Arafat Fashion Garments Ltd. (10495)

J.K. Shirt & Fabric Ltd. (10506)

21.MAY.2014

1st Priority 2 Concern

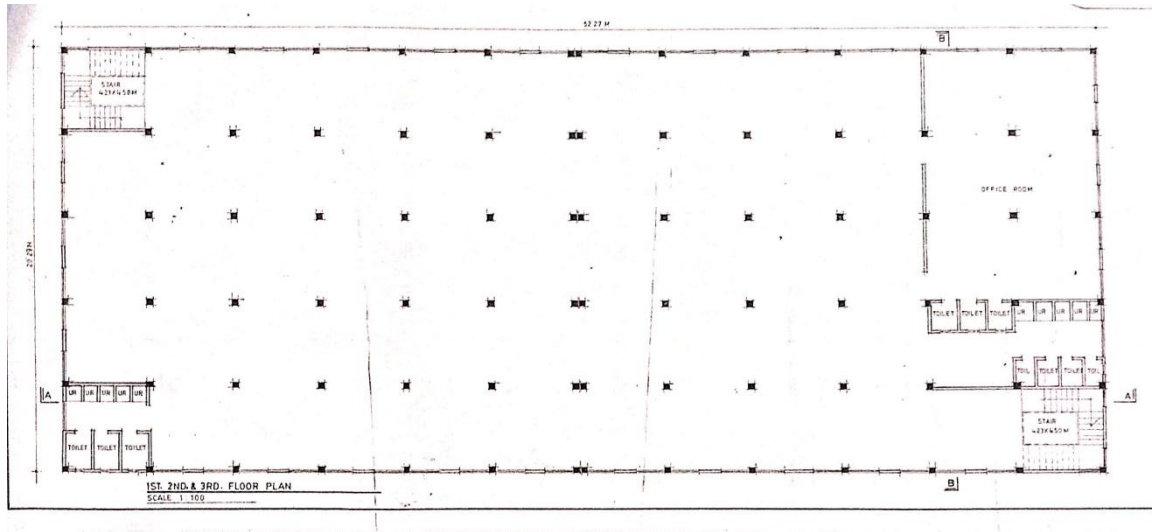
Structural drawings do not match existing conditions:

- Beam layout on the 1st and 3rd floor
- Grid layout

Architectural Drawings used for Permit

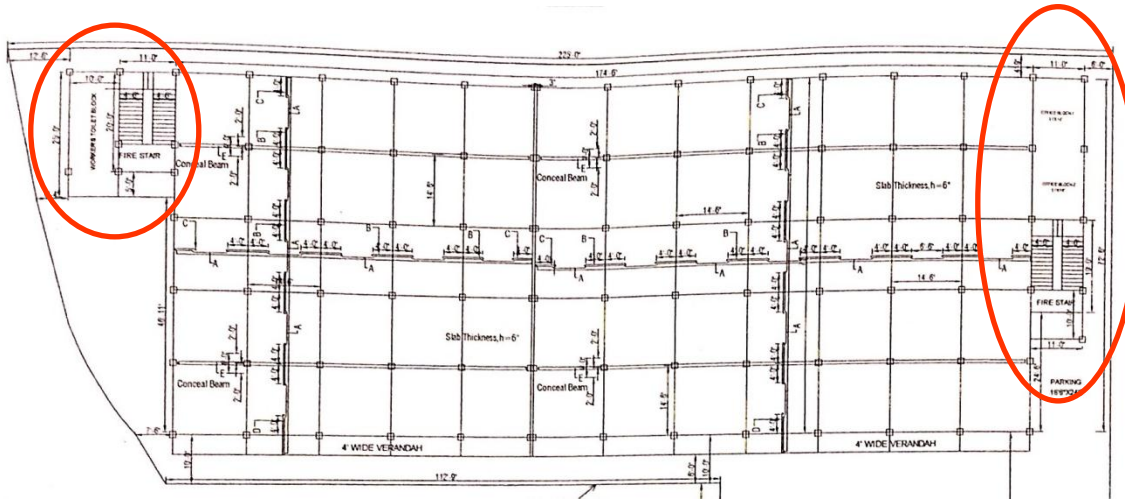
Permit drawings do not match structural drawings or as built conditions.

Additional stairwell bays were constructed on both sides of building (see below).
